RTS-TB-018**23-April -2013****Audible Hum / Noise Emitted from KP-32 Family Displays**

RTS™ TECHNICAL BULLETIN

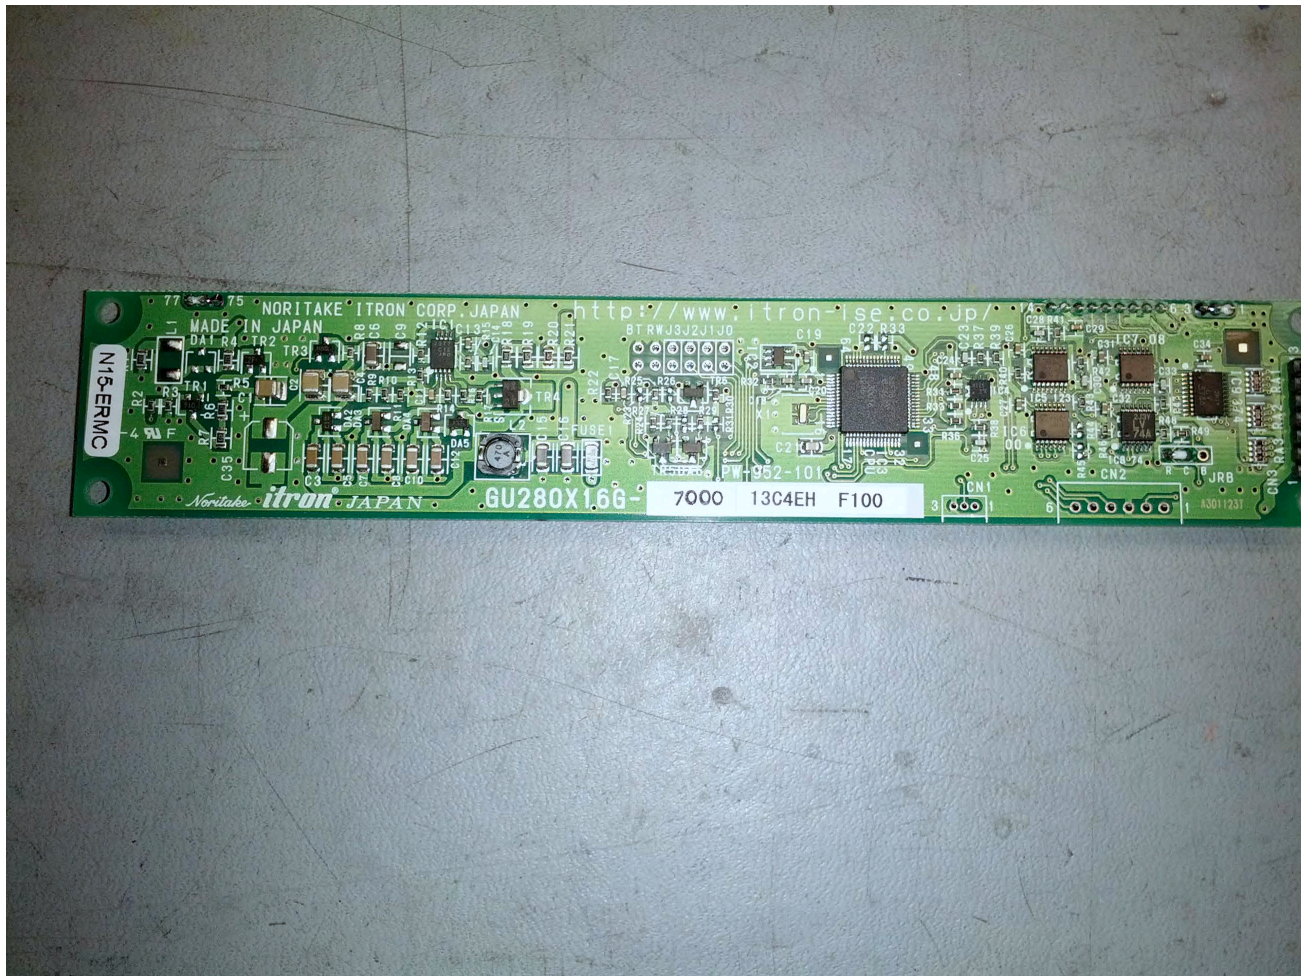
4. Verify that the display boards are the graphical models with the GU280X16G-7000 designation in silkscreen on the back of the board.

Note the part number GU280X16G-7000 marked on the display PCBA and on the lower left side of the board notice the pads for capacitor C35.

5. On the backside of the Noritake board locate reference designator C35. This location should be unpopulated on the PCBA.

This capacitor is part of the Noritake PCBA assembly (not an assembly Bosch manufactures). As such, the addition of the capacitor must be reworked on each display assembly impacted by this issue. Note that this capacitor location (C35 on the Noritake PCBA) is currently not populated.

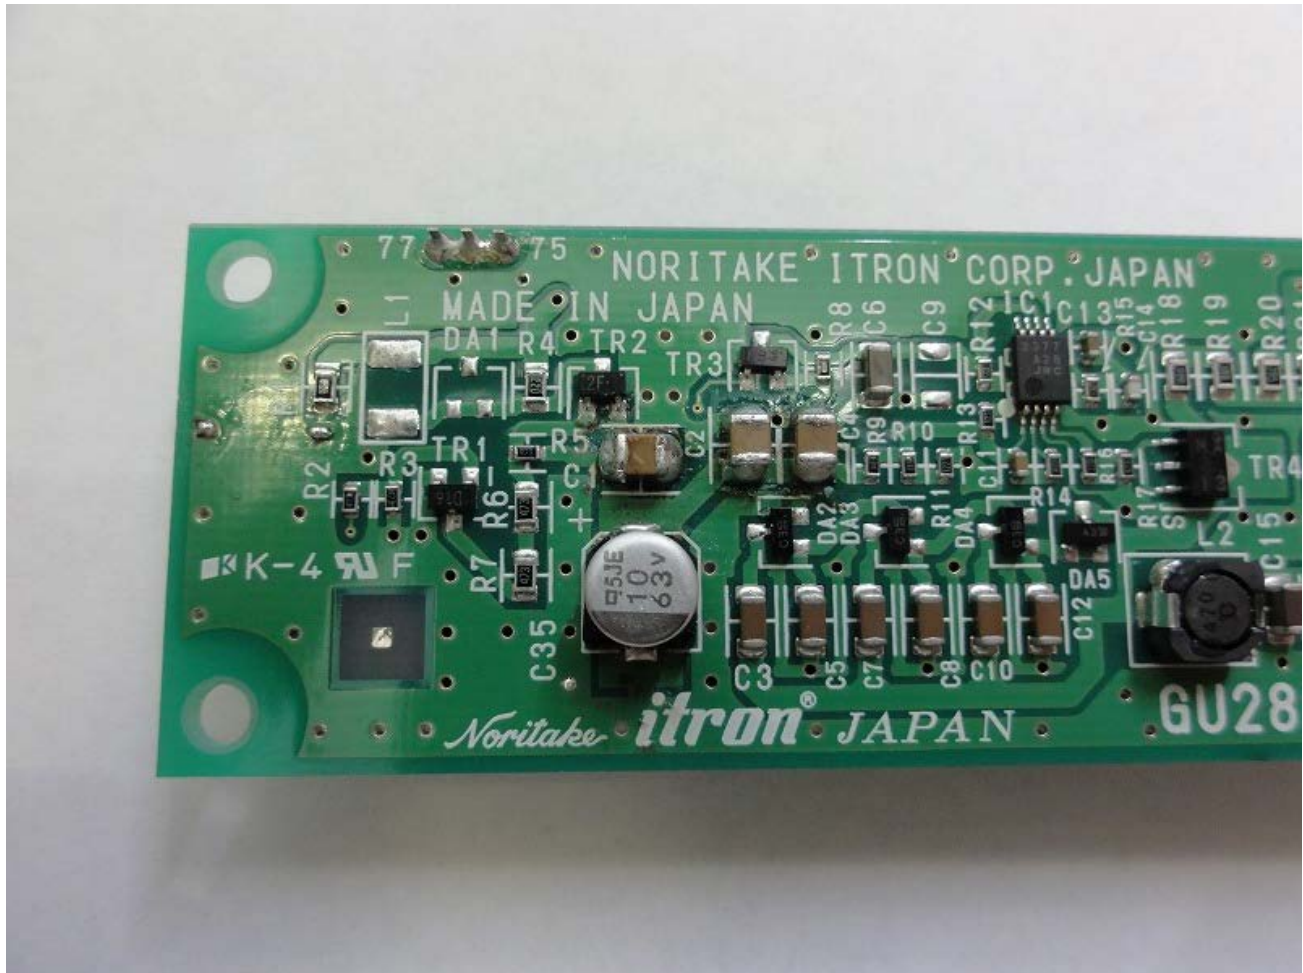
6. Take the 10 uF 63 Vdc electrolytic capacitor (**United Chemi-Con EMVE630ADA100MF55G or equivalent**) and solder to each Noritake PCBA.

Note that this is a polarized capacitor and the polarity must be maintained in the same orientation as shown in the following photo:
